寄件者: TsangShun Qi <[REDACTED]>
寄件日期: 2026年04月13日星期一 16:01
收件者: Timothy Wai Pui WU/PLAND
主旨: A/NE-TKLN/126 - response to comment
附件: swept path 19.pdf; swept path 18.pdf; swept path 17.pdf; response to TD comment.pdf
類別: Internet Email

A/NE-TKLN-126, Response to comments

Transport Department (TD)

Annex 17

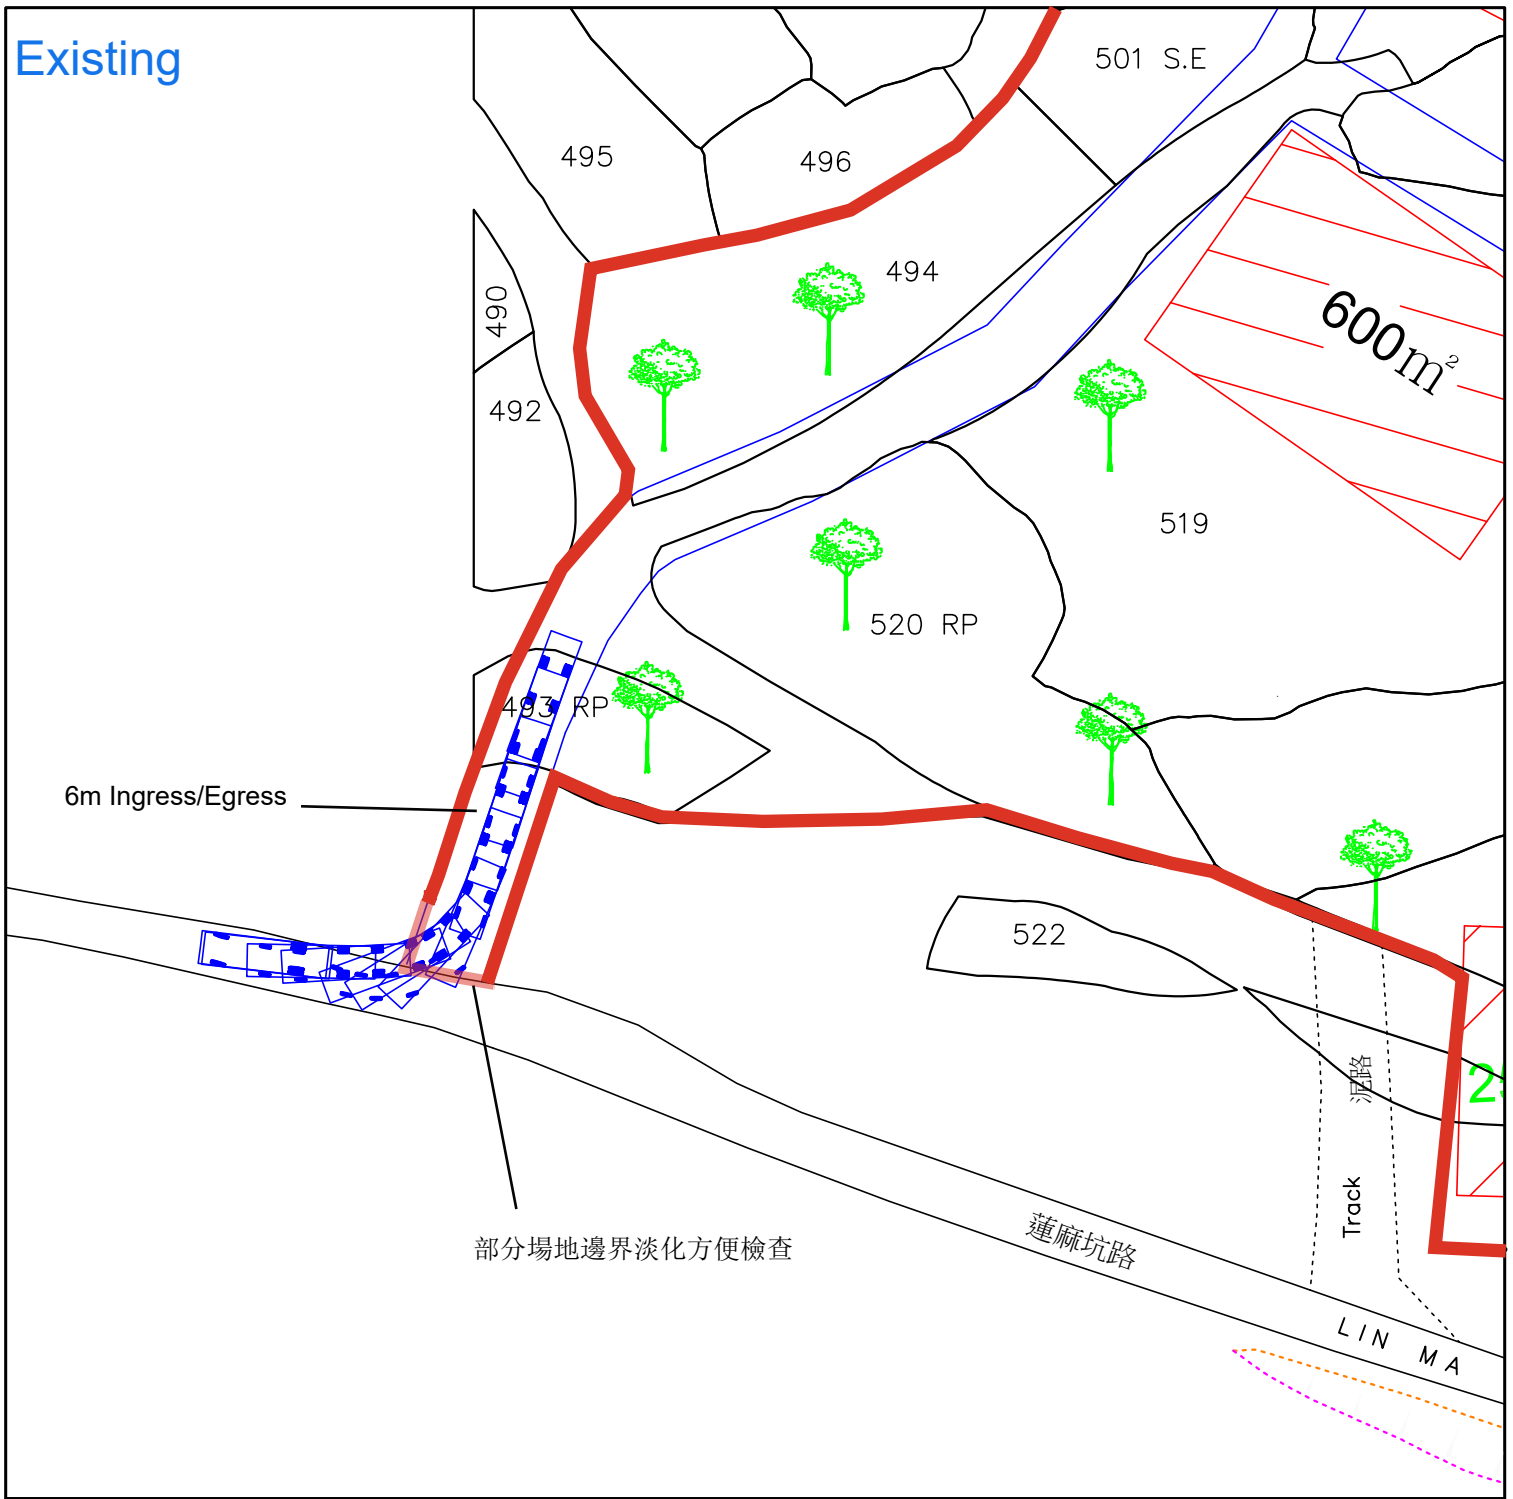
the applicant should demonstrate the satisfactory maneuvering of the goods vehicles when exiting the subject site via the three ingress/egress points;

The related swept path plans are provided.
